Memorandum Planning and Urban Development Department Planning Division

Date: April 20, 2018

Re: **April 24th 2018 Planning Board Workshop**
Level III Site Plan, IOZ Conditional Use
30 condominium/retail development, 56 Hampshire Street (#2017-294)
NewHeight Group LLC, Chip Newell, Applicant

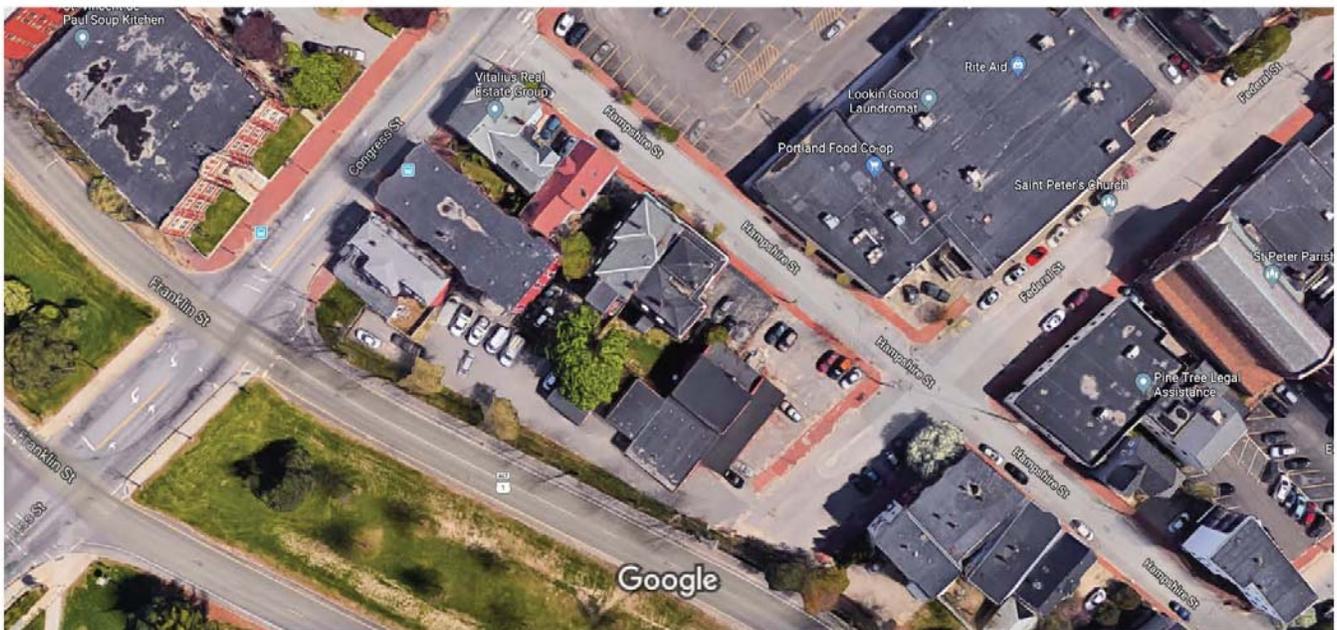
Staff design review has struggled a little bit with how this building can mediate these two contexts. From a massing perspective, the project is successful. However, staff concluded that the project compatibility with the Hampshire, Federal, and Congress Street contexts is still questionable. These contexts rely heavily on traditional materials of red brick and clapboard and have symmetrical façade compositions.
